HISTORIC AND DESIGN REVIEW COMMISSION

November 16, 2022

HDRC CASE NO: 2022-399
ADDRESS: 363 NORTH DR
LEGAL DESCRIPTION: NCB 7026 BLK 5 LOT 16, E11 FT OF 18
ZONING: R-6, H
CITY COUNCIL DIST.: 7
DISTRICT: Monticello Park Historic District
APPLICANT: Thomas Gandy/GANDY THOMAS R
OWNER: Thomas Gandy/GANDY THOMAS R
TYPE OF WORK: Exterior modifications, fenestration modifications
APPLICATION RECEIVED: July 24, 2022
60-DAY REVIEW: Not applicable due to City Council Emergency Orders
CASE MANAGER: Edward Hall

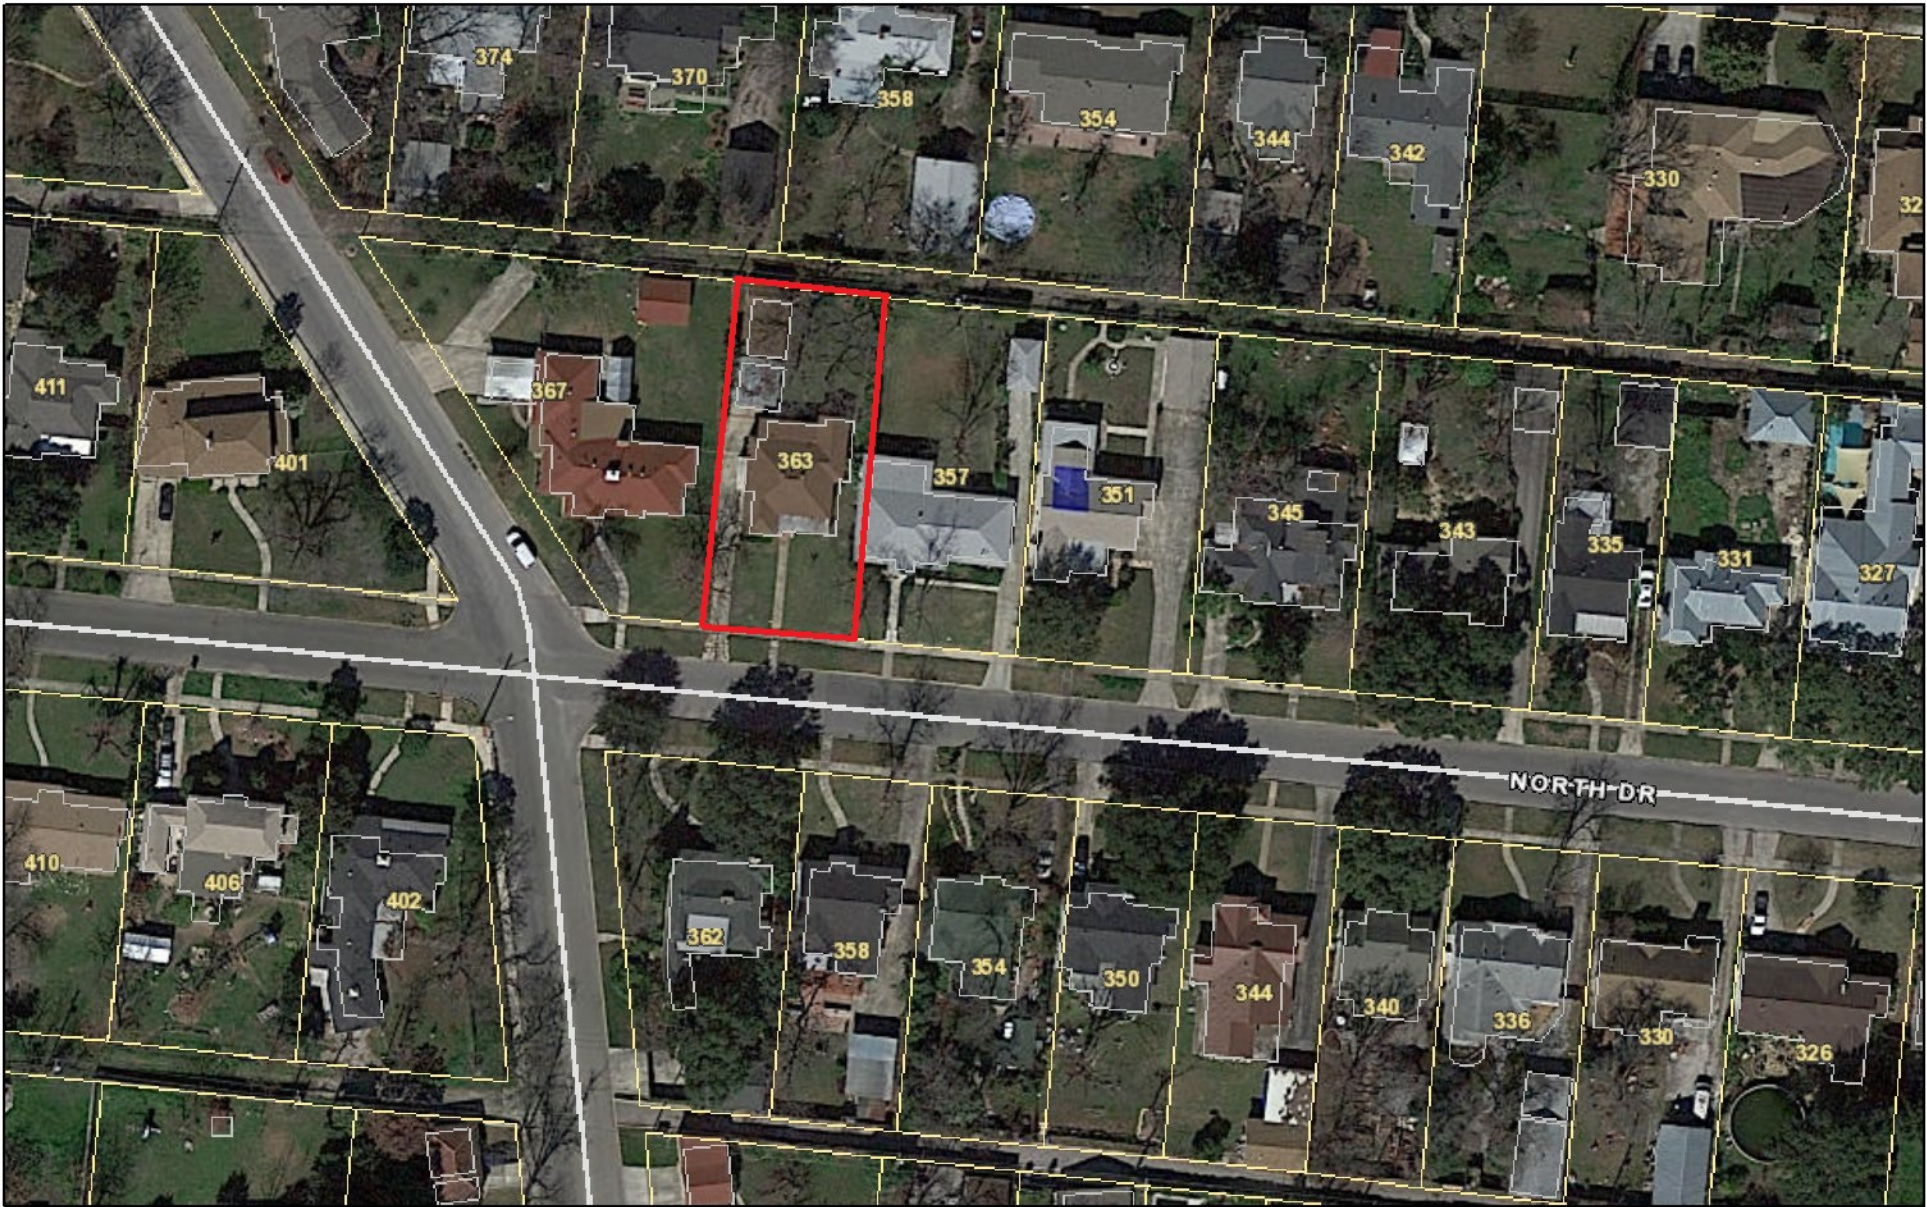
- g. EXTERIOR MODIFICATIONS (Side Façade) – The applicant has proposed to perform modifications to the side (west) façade to include the removal of an existing door opening, and the removal of an existing concrete stoop and steps. Per the Guidelines for Exterior Maintenance and Alterations 6.A.i., exiting window and door openings are to be preserved. The proposal to remove the existing, side door is inconsistent with the Guidelines.

Staff finds this door opening should be preserved in its original location. Additionally, staff finds that the side stoop and porch steps are an original element and should be preserved.

3. Staff does not recommend approval of item #3, modifications to the side (west) façade to include the removal of an existing door opening, and the removal of an existing concrete stoop and steps, as noted in finding g. Staff recommends that the door opening, concrete stoop and stairs be preserved.

1941 SANBORN MAP

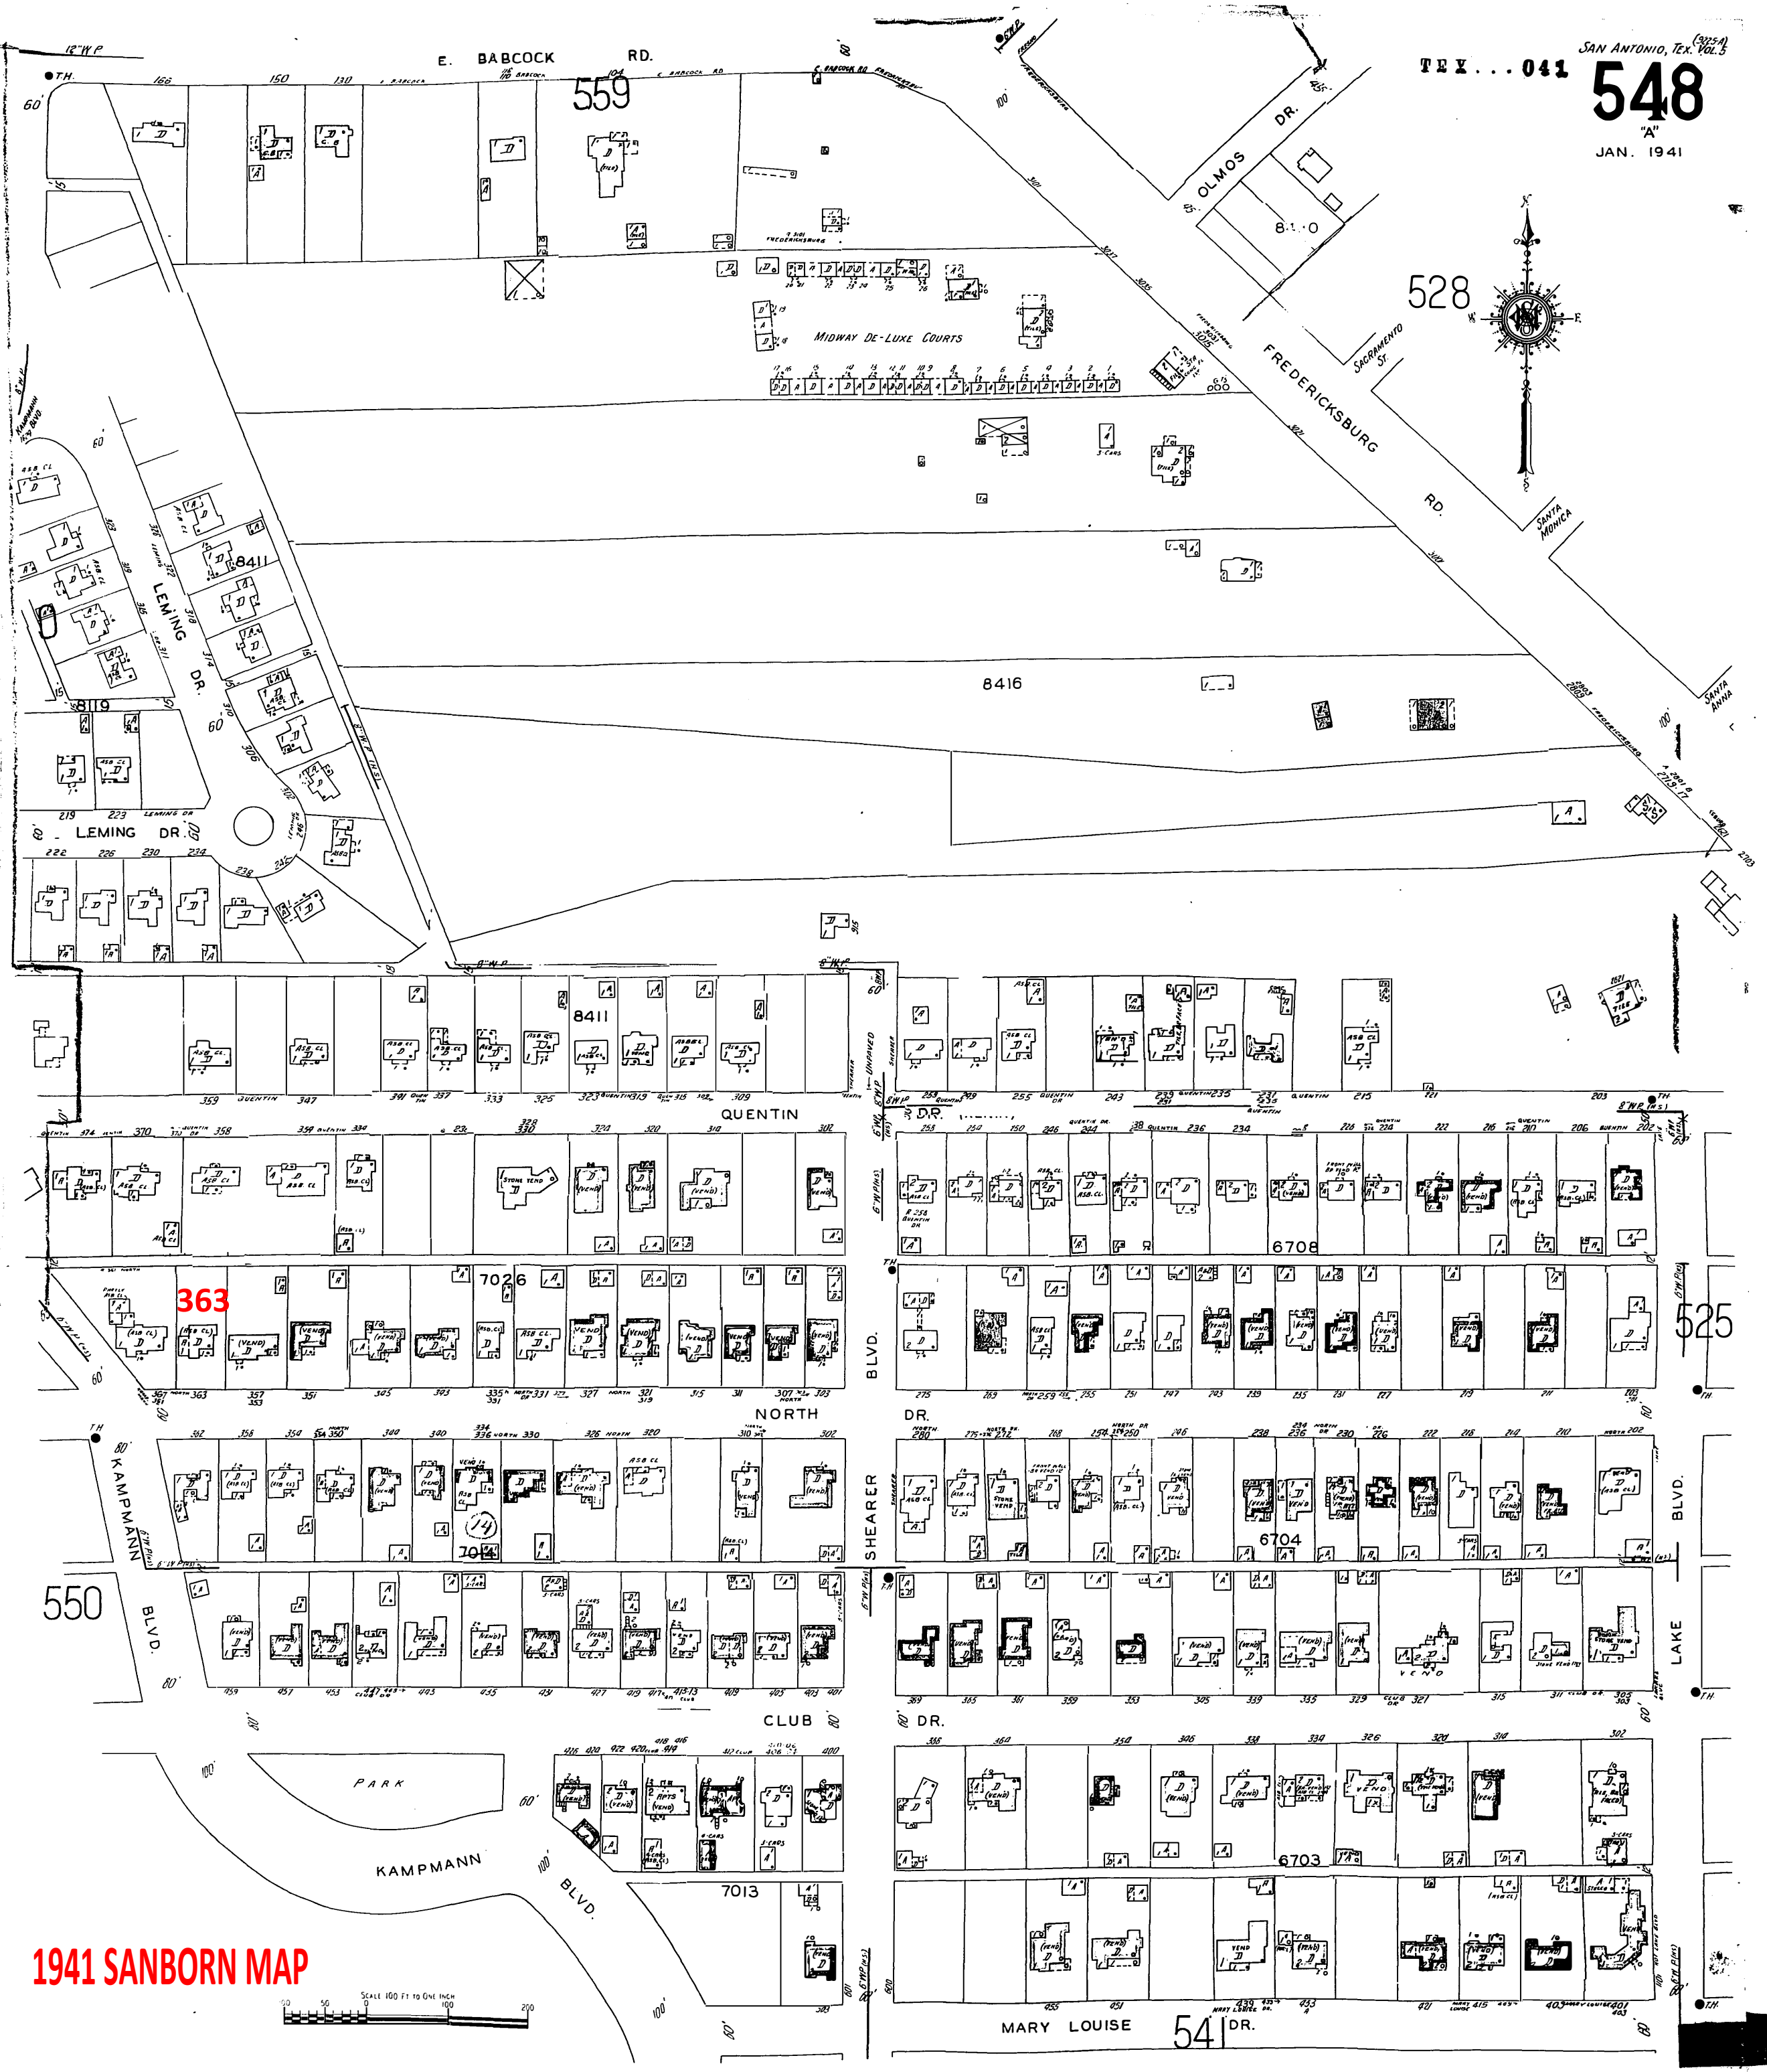
- e. SIDING INSTALLATION – The applicant has proposed to remove the existing façade tiles and brick wainscoting and install horizontal lap siding on each façade. Per the 1941 Sanborn Map, the structure originally features asbestos tiles. Staff finds the removal of asbestos tiles to be appropriate; however, a replacement tile should be installed that preserved the existing profile and appearance of the tiles siding. Many structures of similar form and style found on this block feature masonry (brick or stone) wainscoting. Staff finds the brick wainscoting to be original and finds that it should be preserved.
